TRAFFIC DESIGN		ELECTRICAL DESIGN		REV #		INTERSECTION #088-280	
ENGINEER			ENERGY BY CITY METER # N/A		MAINT LEVEL 5 SERVICE POLE CL&P #7852		UNMETERED SERVICE
DRAWN BY							
CHECKED BY							
SUBMITTED BY							
APPROVED BY							
APPROVED DATE	11	11					
ROUTE 175 (EAST ST.) AT PAUL MANAFORT DR.			TOWN:		NEW BRITAIN		PROJECT NO.
							0093-0218
							DRAWING NO.
							TCS-01
			DRAWING TITLE:		TRAFFIC CONTROL SIGNAL PLAN		SHEET NO.
SCALE 1" = 40'

STATE OF CONNECTICUT
DEPARTMENT OF TRANSPORTATION

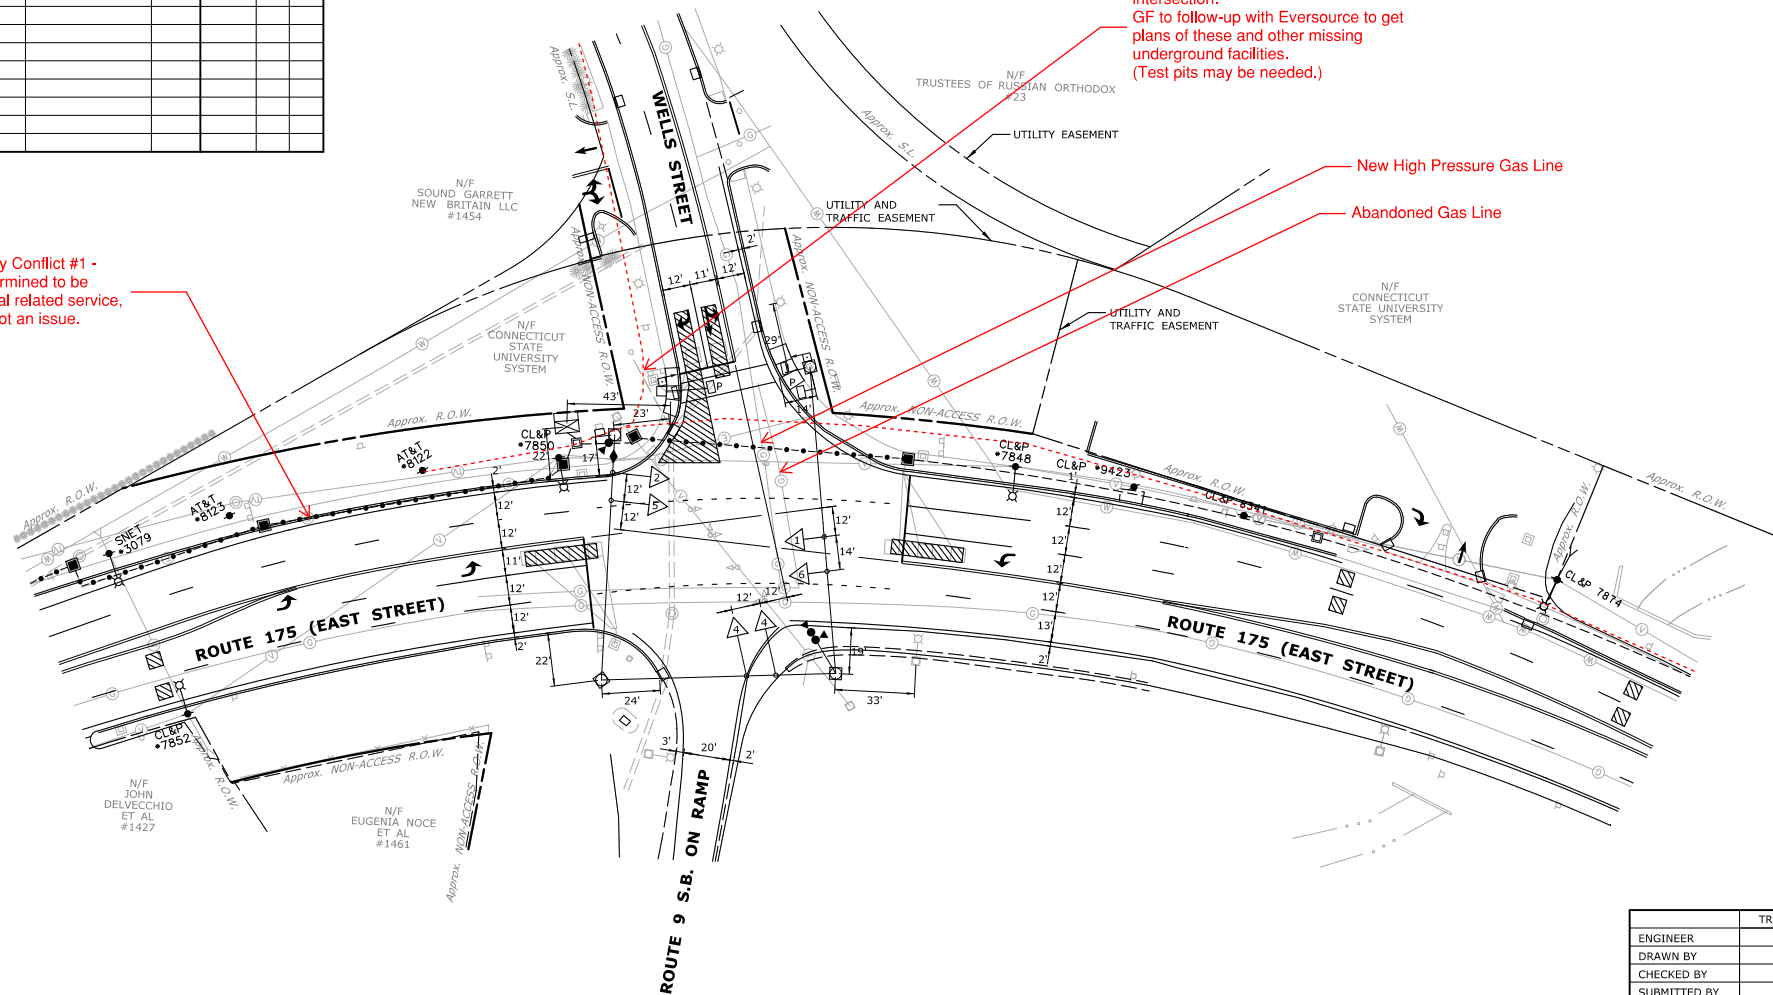
Utility Conflict #1 - determined to be signal related service, so not an issue.

S.R. 505 (ELLA GRASSO BLVD.) AT ROUTE 9 S.B. OFF-RAMP SCALE 1" = 40'	TOWN:	NEWINGTON & NEW BRITAIN DRAWING TITLE: TRAFFIC CONTROL SIGNAL PLAN	PROJECT NO.	0093-0218
	DRAWING TITLE:		DRAWING NO.	TCS-03
				SHEET NO.

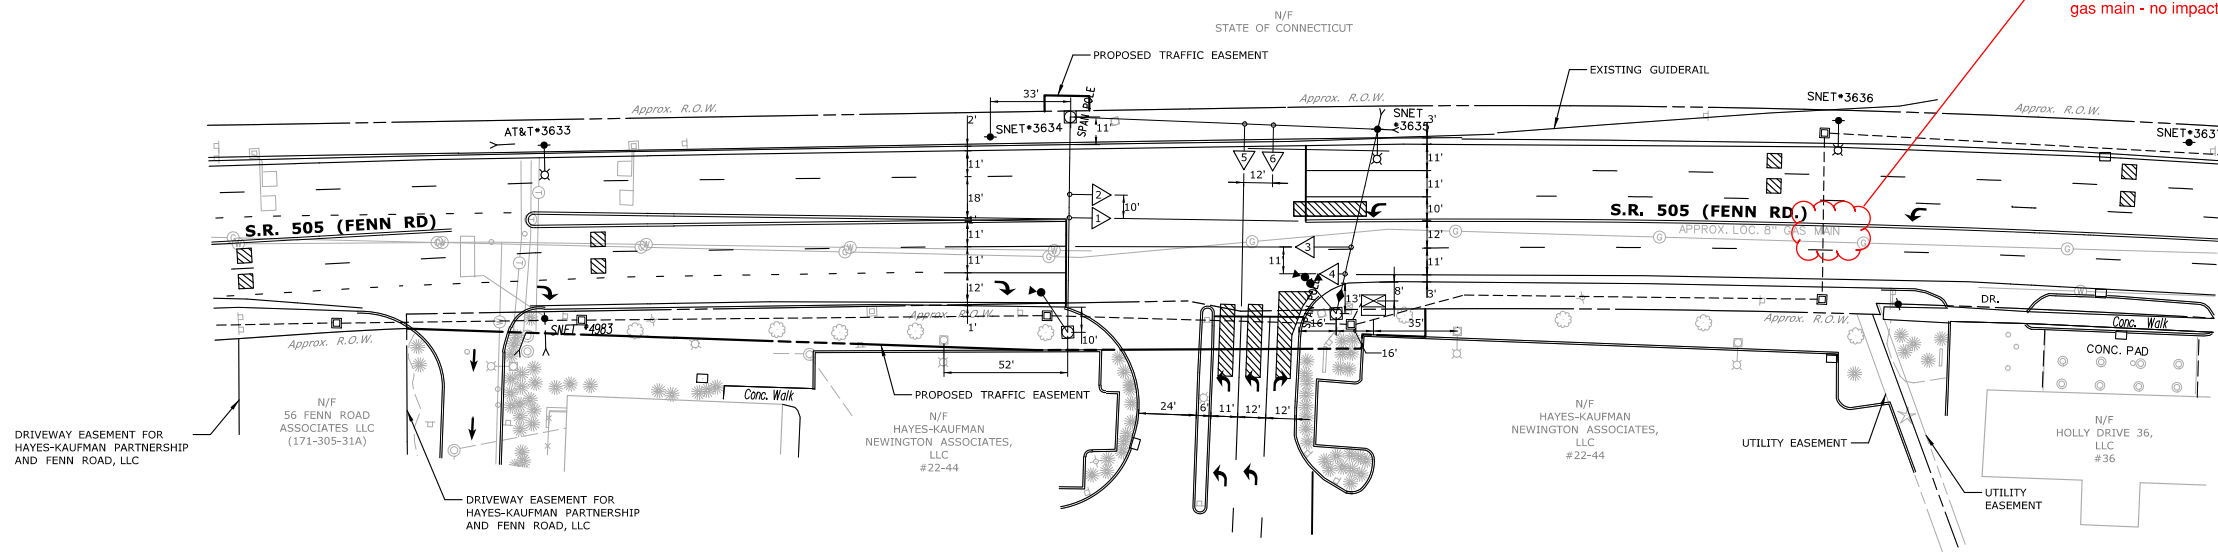
— Eversource has facilities at this intersection.

TOWN:	NEWINGTON	PROJECT NO.
		0093-0218
DRAWING TITLE:	TRAFFIC CONTROL SIGNAL PLAN	DRAWING NO.
		TCS-12
		SHEET NO.

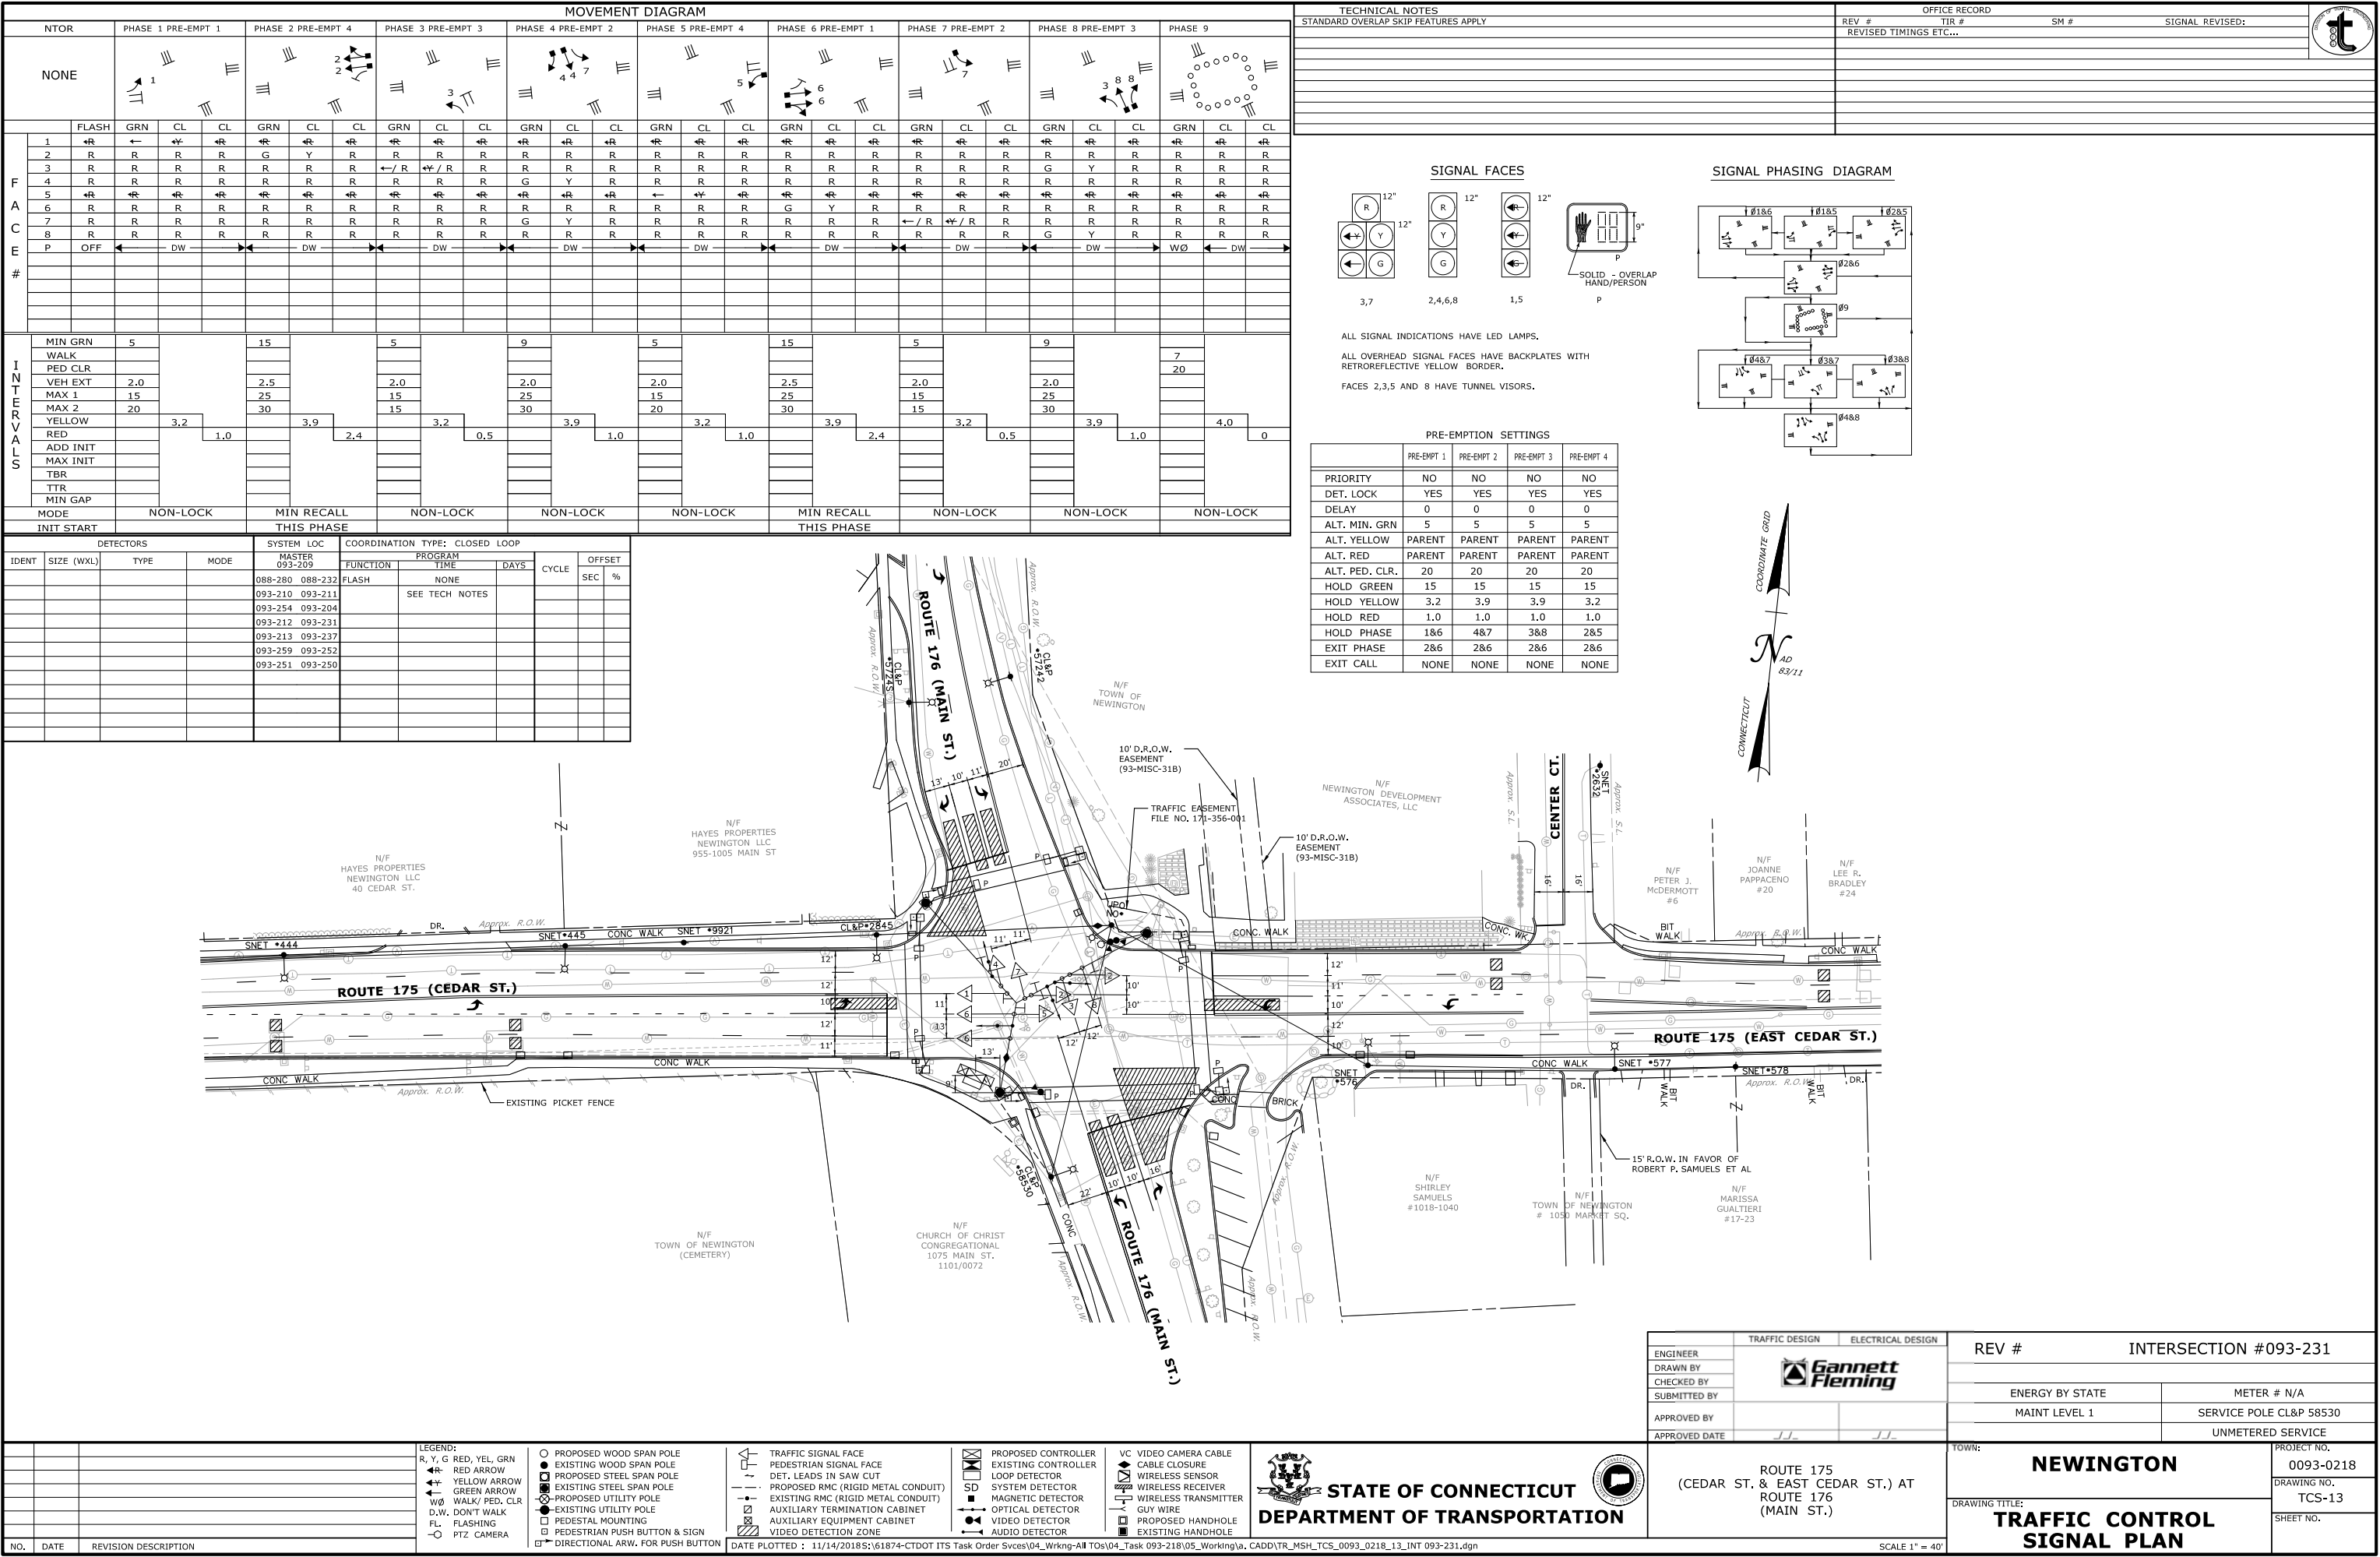
MDC currently reconstructing facilities through this intersection. Update plans to reflect revisions.
